PROGRESS REPORT

Independent Review of Implementation of Revised Seismic Design Criteria Hanford Waste Treatment and Immobilization Plant (WTP)

Revision D

U.S. Army Corps of Engineers
Walla Walla District

Supporting Information to LP-7 Resolution

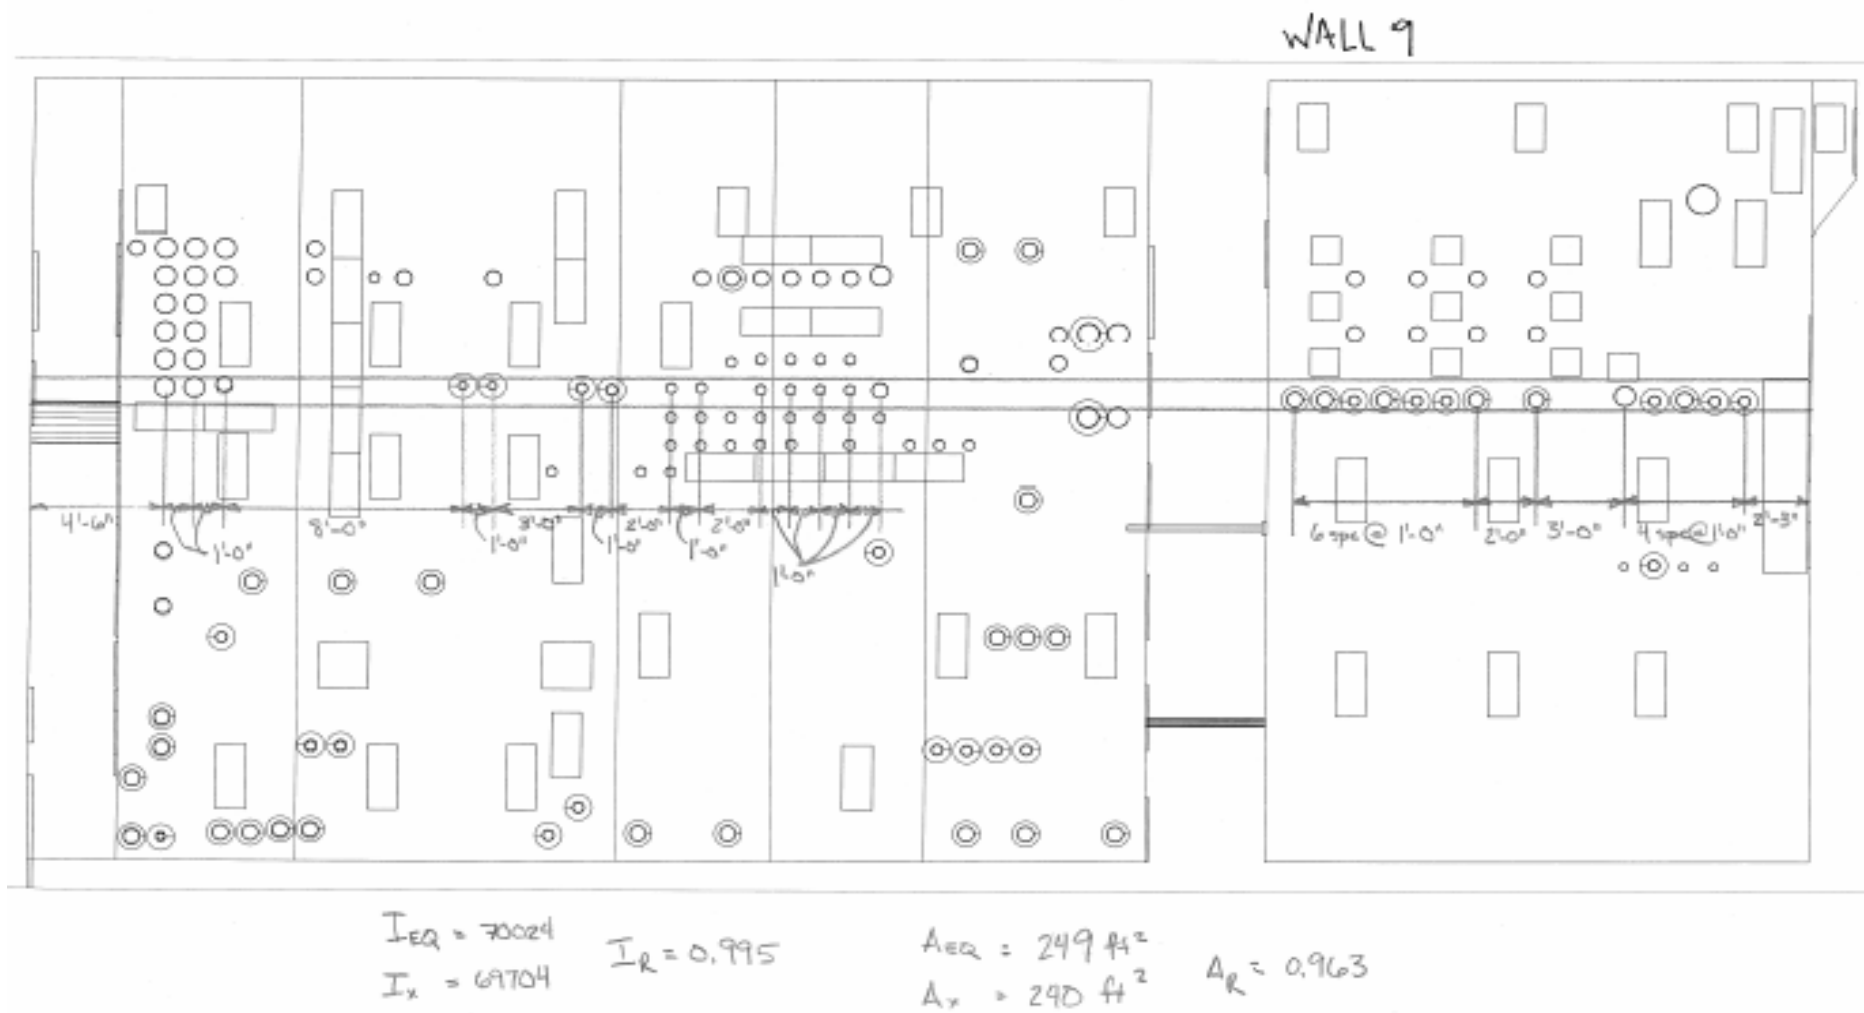
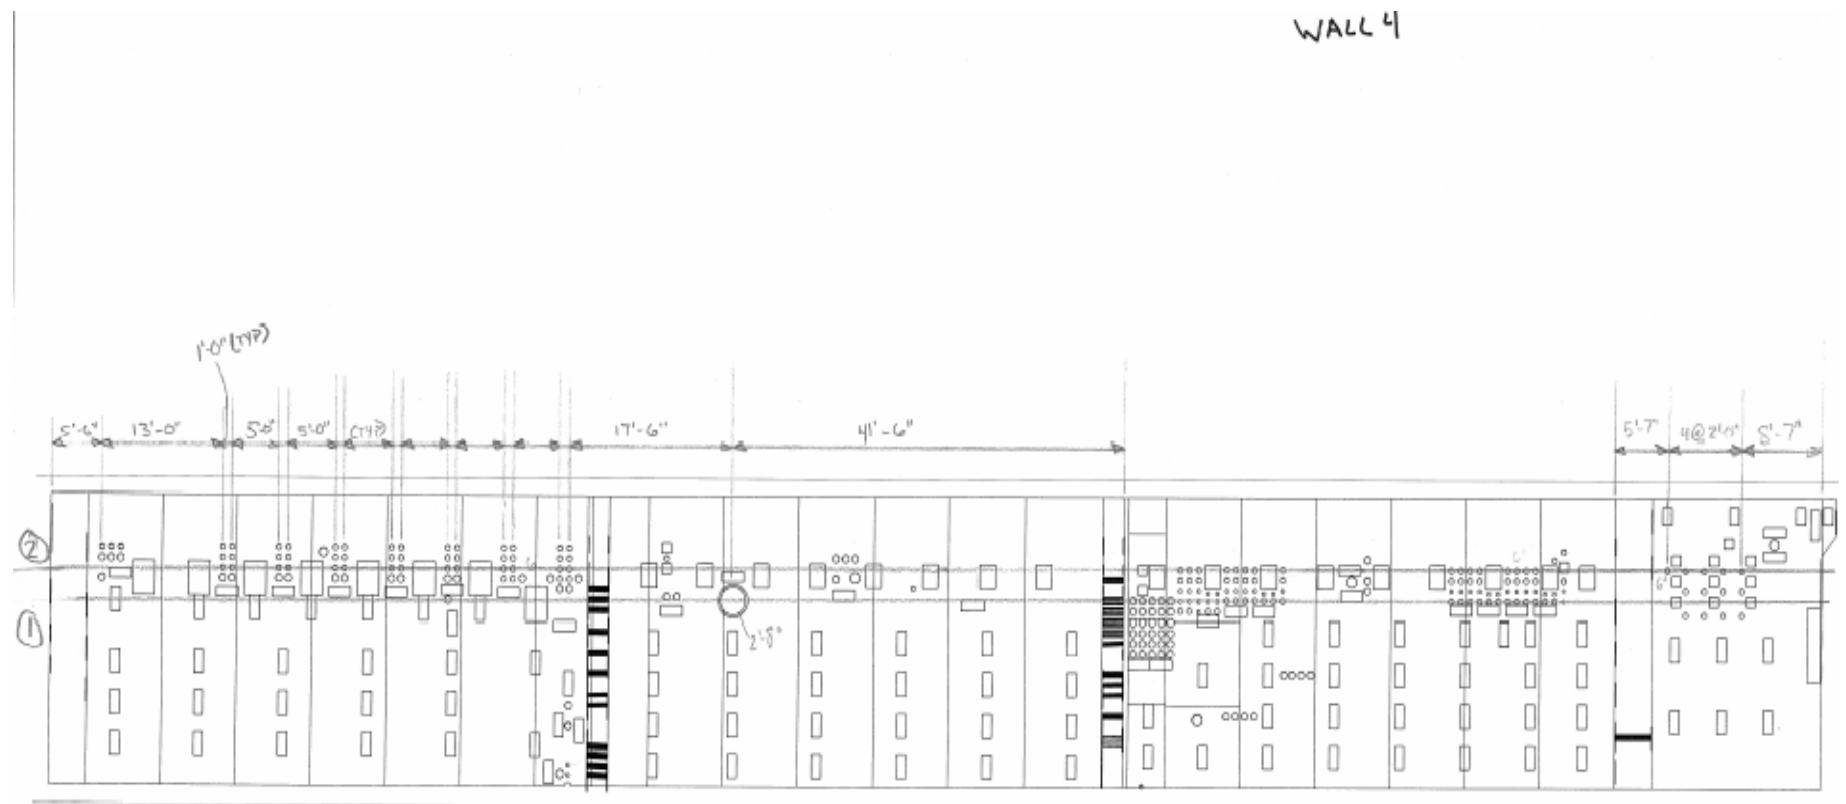
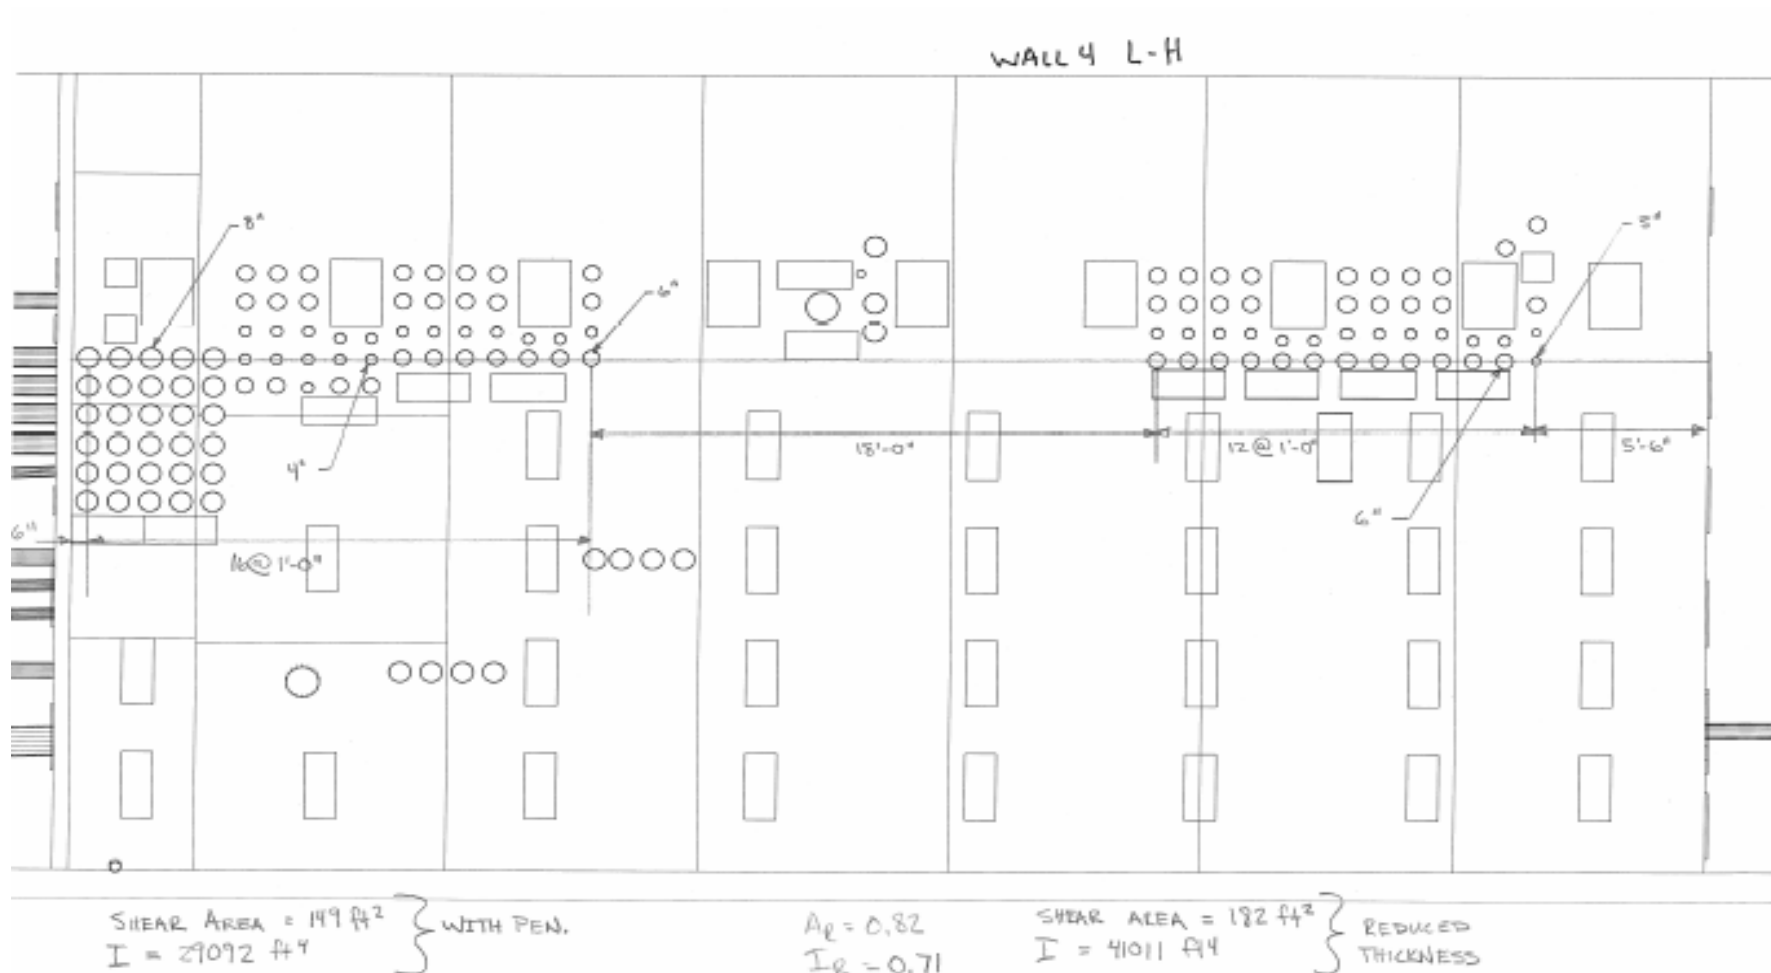
C.3 Load Path Review Comments				
No.	Document	Comments and Observations	BNI Remarks/ Resolutions	Follow-up by USACE Review Team
			<p>the calculation.</p> <p>USACE: b) Observation</p>	
LP-7	<p>24590-PTF-SOC-S15T-00047 Pretreatment Facility Structural Analysis with Refined Structural Model 24590-PTF-P1-P01T-00001 thru 00006 (General Arrangement Plans) 24590-PTF-DB-S13T-x (Structural Concrete Wall Sections)</p>	<p>Reviewer: John Connor</p> <p>a) Wall section 4 is shown on sheet A-17 and modeled on sheet G-4. The wall details can be seen on drawing sheet -S13T-00105. Sheet A-17 shows hundreds of sleeve penetrations, some closely spaced and ganged together. Some of the penetrations groupings cover an area comparable to other doors or windows. The model shown on sheet G-4 does not show any openings to represent the ganged pipe penetrations. The model is shown with various colors, which appear to indicate wall thickness changes. The colors appear to correlate with the wall thickness changes rather than equivalent element thicknesses. It appears that an equivalent element thickness was not considered for these ganged openings.</p> <p>b) Wall section 9 is shown on sheet A-19 and modeled on sheet G-10. The wall details can be seen on drawing sheet -S13T-00113. Sheet A-19 shows hundreds of sleeve penetrations, some closely spaced</p>	<p>BNI/Jeffrey:</p> <p>(a) Wall on column line 4 carries a large number of pipe sleeves in the area between col lines H and L and elevations 38' and 56'. These sleeves vary in diameter from 3" to 8" and thickness of material is schedule 40 up to 6" dia and schedule 20 for 8" dia and larger. All sleeves 3" dia or larger are provided with shear studs. Wall detailing is such that no reinforcing bars are cut to accommodate the sleeves, which are approx 12" c/c min.</p> <p>These openings are not shown in the model as penetrations; however, in the above area wall thickness is reduced from 4' to 3'-6" to account for loss of concrete. Note that the pipe sleeves with shear studs restore some strength in the area where concrete is lost due to penetration; however, this strength is not included in arriving at equivalent element thickness. This wall in its entire length carries 13.9 % of the N-S shear. Approx. 1/4 of its length and 1/3 of its height is reduced in thickness from 4' to 3'-6". We have further reviewed this and compared the Moment of Inertia and Shear area at the penetrations on</p>	Closed.

C.3 Load Path Review Comments				
No.	Document	Comments and Observations	BNI Remarks/ Resolutions	Follow-up by USACE Review Team
		<p>and ganged together. Some of the penetrations groupings cover an area comparable to other doors or windows. The model shown on sheet G-10 does not show any openings. The model is shown with 2 colors, which appear to indicate wall thickness changes. The 2 colors appear to correlate with the wall thickness change from 5' to 4'. It appears that an equivalent element thickness was not considered for these ganged openings.</p> <p>c) The load path is not clear, considering that the arrangement and sizes of penetrations varies throughout the wall. It may not be practical to model these ganged pipe penetrations as "holes" in the main SAP building model. Using the equivalent wall thickness approach seems appropriate for the main SAP building model. Walls sections, such as wall 4 and 9, should be modeled separately. A single wall section could be modeled as a stand-alone SAP model file, using forces obtained from the global SAP model file. The single wall section could be modeled with greater detail to account for the ganged penetrations.</p>	<p>attached sketches and spreadsheet (following this table of comment resolutions: Sketches- 3 in total, Spreadsheet - 1 in total). It can be seen that while this wall becomes more representative of its physical properties, the actual redistribution of load is negligible. This is due to (a) reduced concrete thickness is over a small portion of wall, approx 25%, and (b) shear capacity is dominated by reinforcing steel.</p> <p>(b) Wall on col line 9 also carries a large number of pipe sleeves in the area between col lines C and E and elevations 38' to 56'. These sleeves are similar to those described in item (a).</p> <p>These openings too are not shown in the model and wall thickness is reduced from 5' to 4' to account for penetrations.</p> <p>This wall carries only 2.8 % of N-S shear and same reasoning applies here as indicated above in item (a).</p> <p>(c) See LP-8</p>
